**Minerals Plan of Operations Inspection**  
**U.S. Department of the Interior**  
**Bureau of Land Management**  
**Royal Gorge Field Office**

<b>Date:</b> 08/10/2018 <b>Time:</b> 11:24 am <b>Weather:</b> Sunny	<b>Operation Name:</b> Gold Tamers-Field of Dreams Mine <b>Operator:</b> Gold Tamers <b>Case Number:</b> COC73930 <b>CDRMS #:</b> M-2009-056
<b><u>Attendees</u></b> BLM: Amber Sanderson & Sam Marolt  Operator(s): Contacted, but not present  Other(s): None	<b><u>General</u></b> Operation(s) are in compliance with documentation on file <input type="checkbox"/> Yes <input checked="" type="checkbox"/> No <input type="checkbox"/> N/A Operation(s) and disturbance on-site coincide with the operations and access on file <input type="checkbox"/> Yes <input checked="" type="checkbox"/> No <input type="checkbox"/> N/A

**Image 10:**

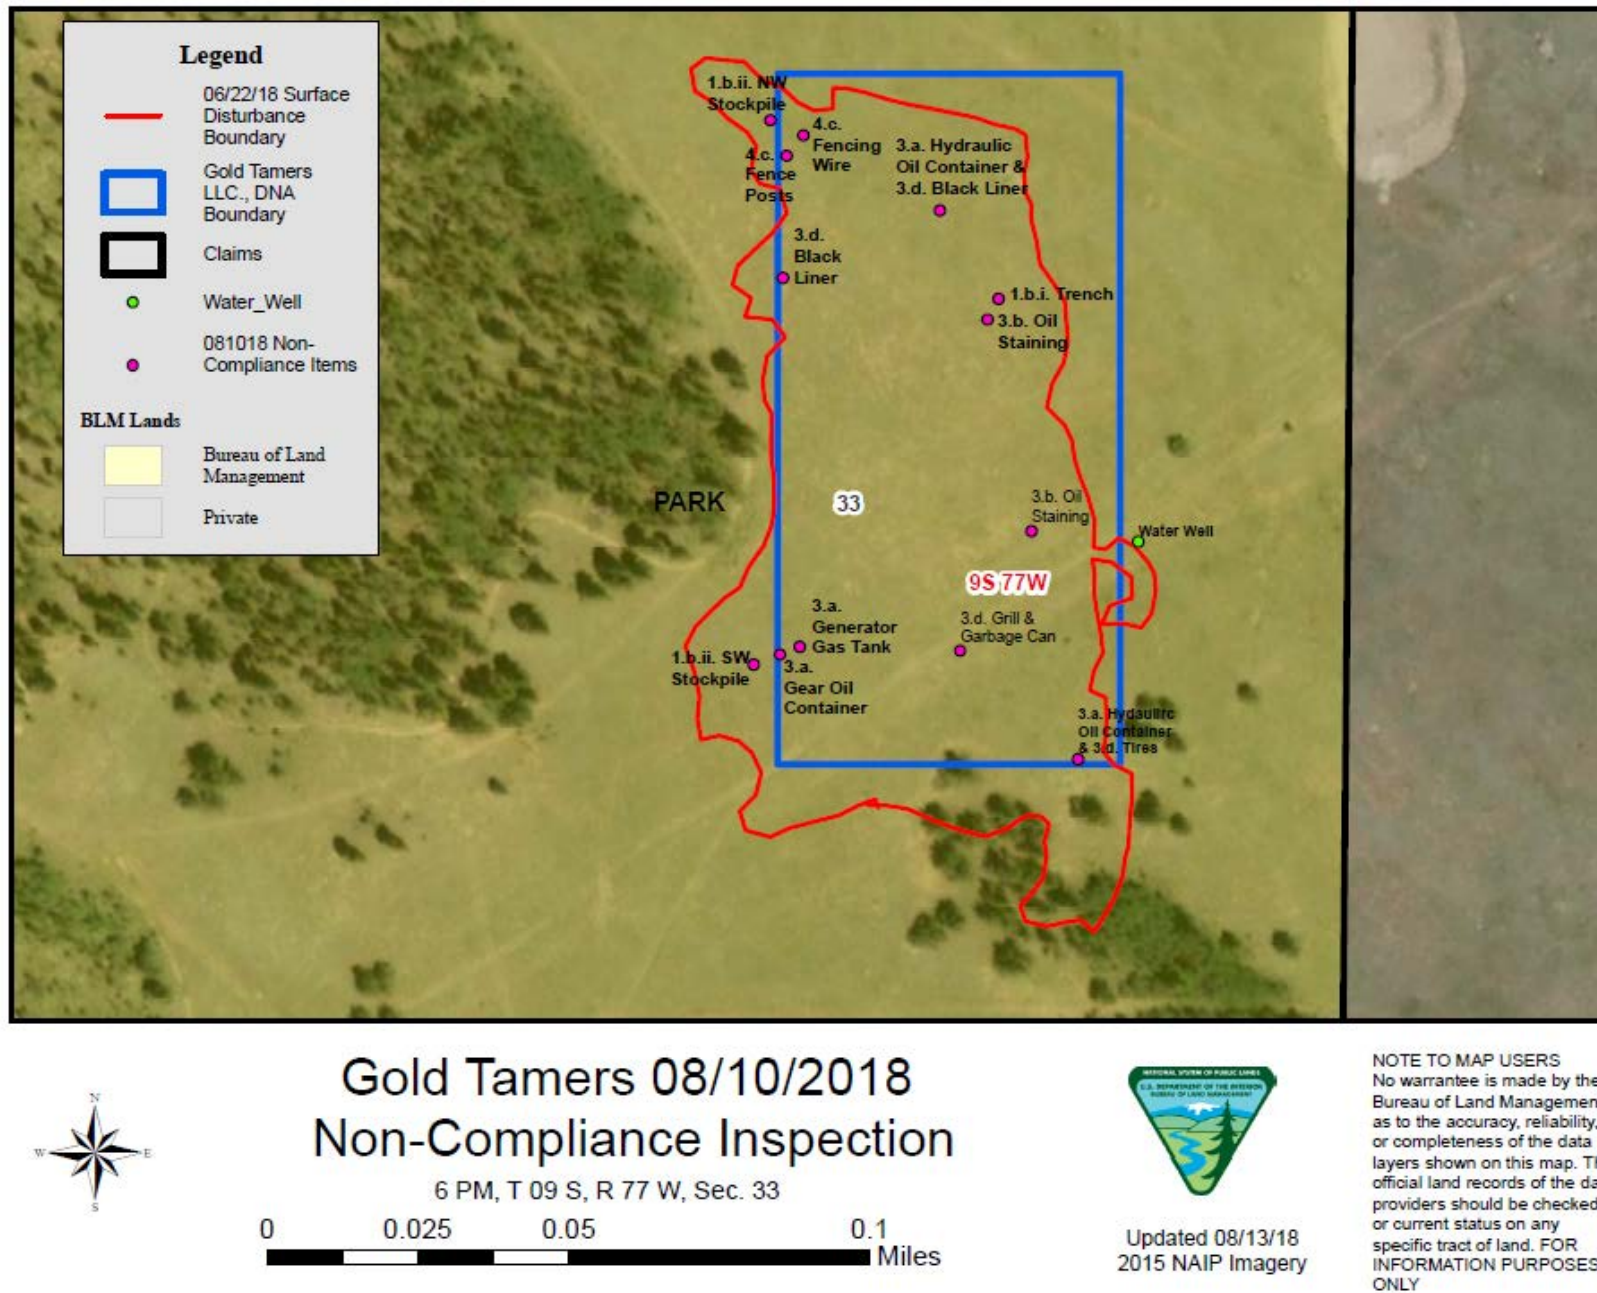
Comment: General site overviews
